GSI Job No. 5844 Issued: 14 September 2021

APPENDIX A RESPONSE TO COMMENTS PROVIDED TO TTL ON APRIL 14, 2021 BY DR. JAMES KENNEDY (KENNEDY, 2021) AS PART OF A TWIN PINES PERMIT COORDINATION DOCUMENT

RESPONSE TO COMMENTS PROVIDED TO TWIN PINES MINERALS, LLC ON SEPTEMBER 10, 2021, BY GEORGIA DEPARTMENT OF NATURAL RESOURCES ENVIRONMENTAL PROTECTION DIVISION AND DR. JAMES KENNEDY (EPD, 2021)

Figure 4 Aerial Distribution of Consolidated Black Sands

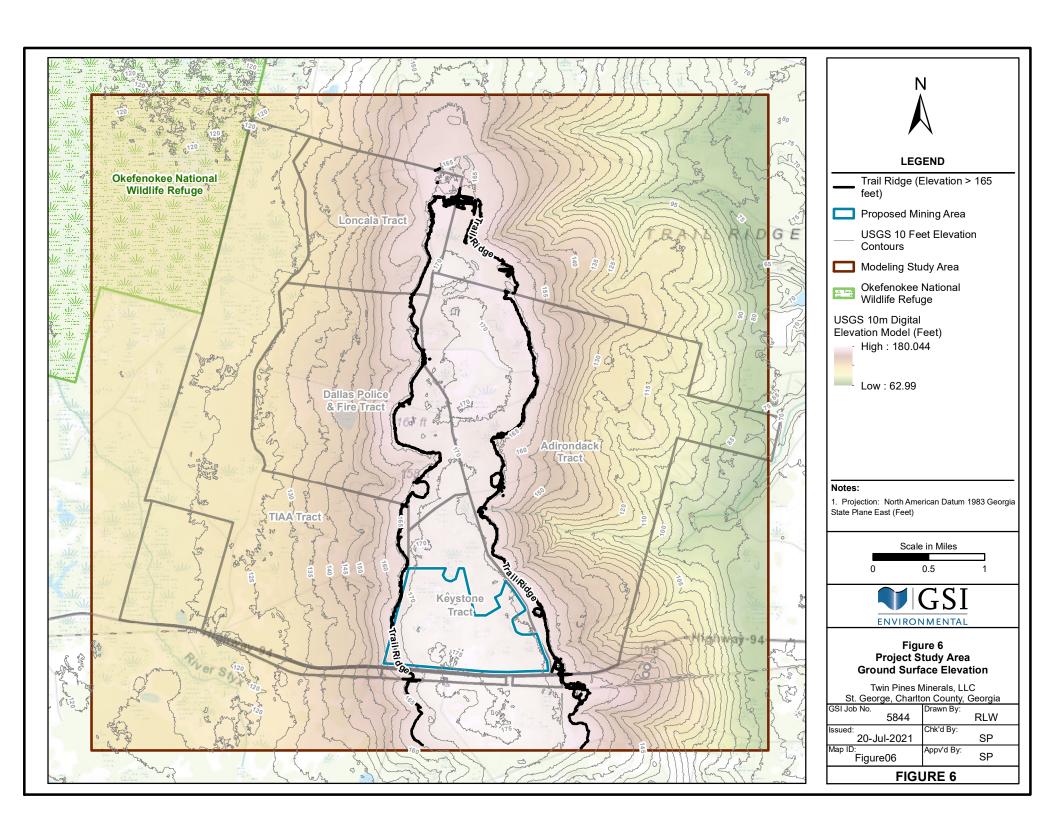
Comment 6b: This comment requests use of data to determine presence or absence of consolidated black sands.

Response: We have mapped the logs with presence and absence of consolidated black sands and used that information to delineate locations where consolidated black sands are present and where they may be absent. This is detailed in GSI (2021). This data indicated that the study area was mostly covered with continuous black sands with small areas where they did not exist, and a small zone showing a transition between where the continuous black sands exist and where they do not.

Figure 16 **Consolidated Black Sands** (Hydrostratigraphic Unit 2) **Hydraulic Conductivity**

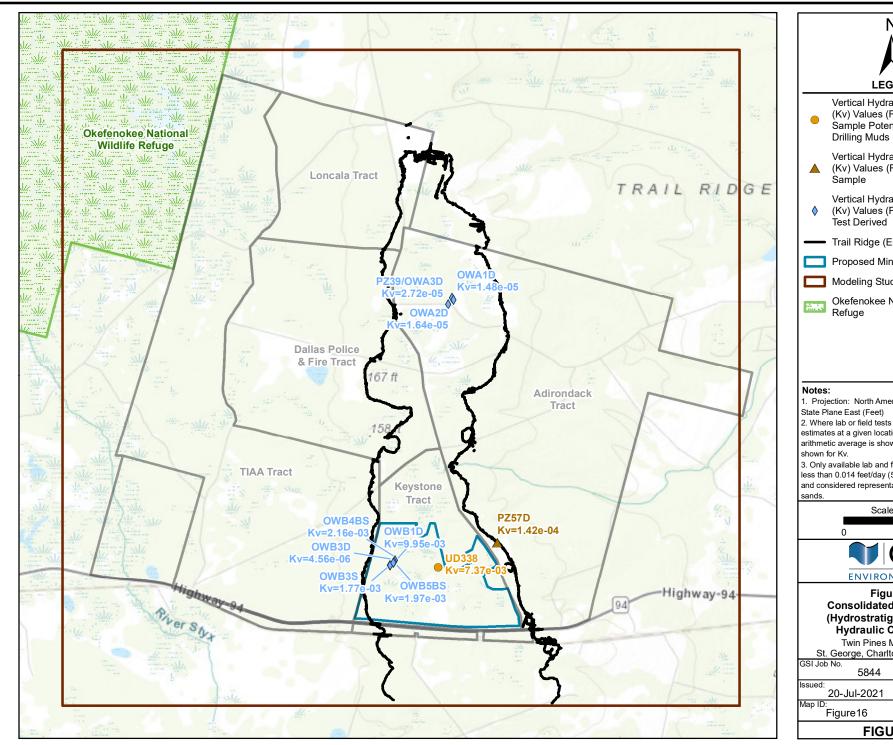
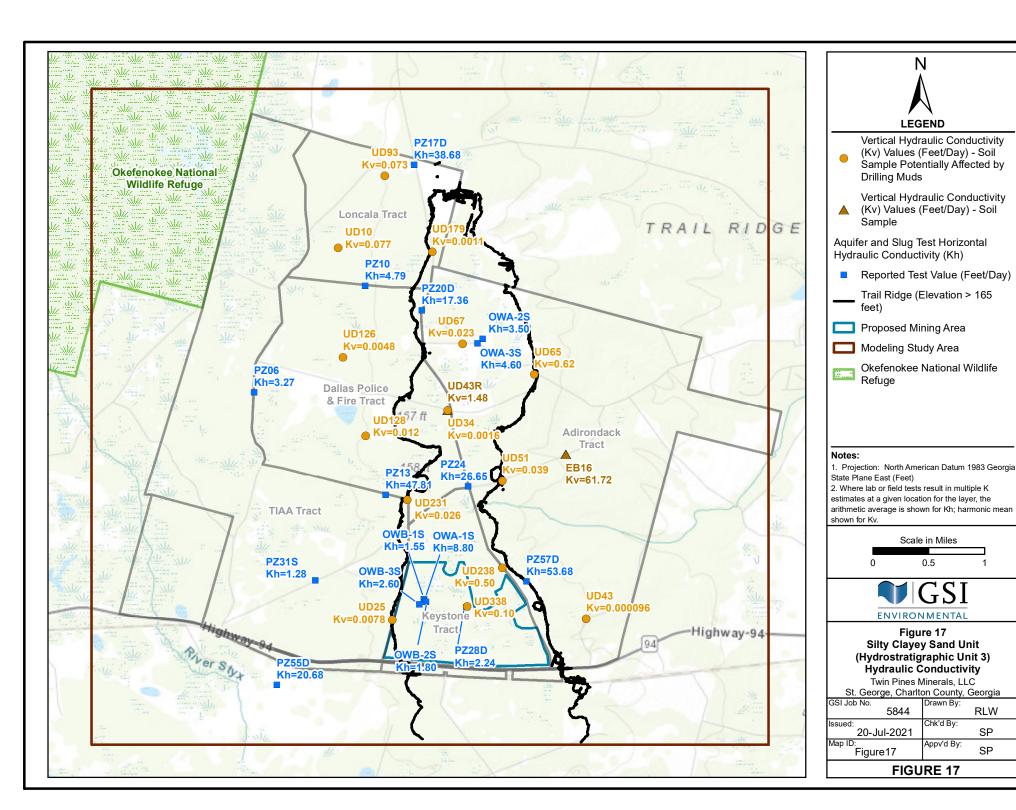
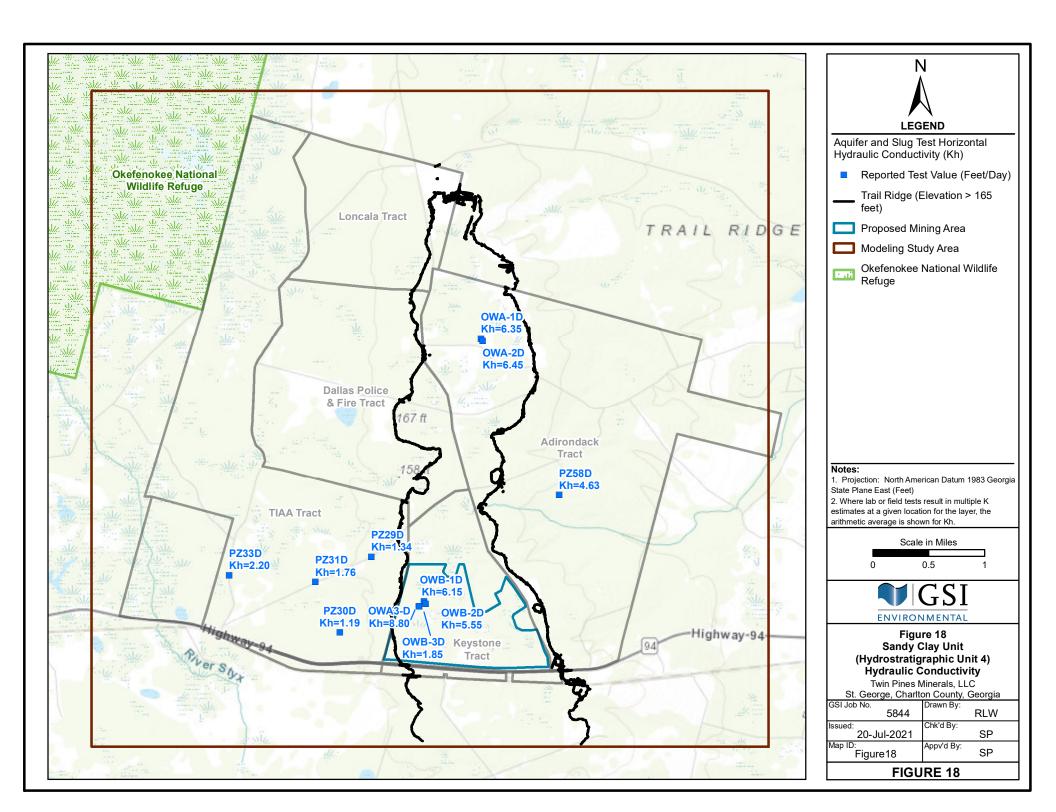
Comment 6c: This comment requests use of hydraulic conductivity values for consolidated black sands that are in line with data from the site. Also, the comment indicates that slug test data that show higher values may not be appropriate for consolidated black sands.

Response: We have mapped the hydraulic conductivity estimates from laboratory and field experiments in GSI (2021). They are low in the range of 10^{-6} to 10^{-8} cm/sec as noted by GA EPD and that higher values in the range of 5×10^{-5} to 10^{-2} cm/sec may indicate composite conductivities with overlying and underlying materials. The model developed in GSI (2021) also uses values in the range of 10^{-6} to 10^{-8} cm/sec for the consolidated black sands.
